(Single Family Residential and Accessory Structures)	
Grand Junction Department of Community Development	
SUBDIVISION Williams	BLDG(S)/ADDITION
FILING BLK LOT	BLDG(S)
TAX SCHEDULE NO. 2945-243-11-019	NO. OF FAMILY UNITS
ADDRESS 653 WINTERGREEN	NO. OF BLDGS ON PARCEL BEFORE THIS CONSTRUCTION
TELEPHONE 434-8911	PERSONAL ROS.
REQUIRED: Two plot plans showing parking, setbacks to all property lines, and all rights-of-way which abut the parcel.	
ZONE RSF-8	DESIGNATED FLOODPLAIN: YESNO X
SETBACKS: Front	GEOLOGIC HAZARD: YES NO
from center of ROW, whichever is greater	census tract 3 traffic zone 80
Side 5 from property line	PARKING REQ'MT
Rear	SPECIAL CONDITIONS:
Maximum Height 32	
Maximum coverage of lot by structures 45%	
Modifications to this Planning Clearance must be approved, in writing, by this Department. The structure approved by this application cannot be occupied until a final inspection has been completed by the Building Department (Section 305, Uniform Building Code).

February 23, 1994

Subject: Pine Street Improvements Date: 2/23/94 Time: 11:21a

PINE STREET

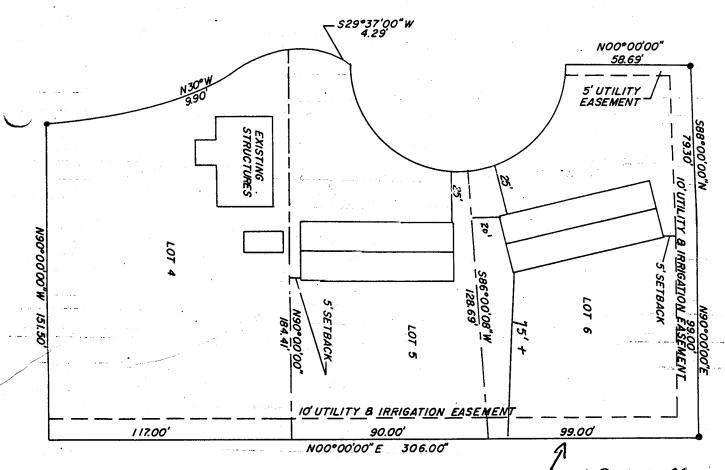
ACCEPTED WO 10-20-43
ANY CHANGE OF SETBACKS MUST BE APPROVED BY THE CITY PLANNING DEPT. IT IS THE APPLICANT'S RESPONSIBILITY TO PROPERLY LOCATE AND IDENTIFY EASEMENTS AND PROPERTY LINES.
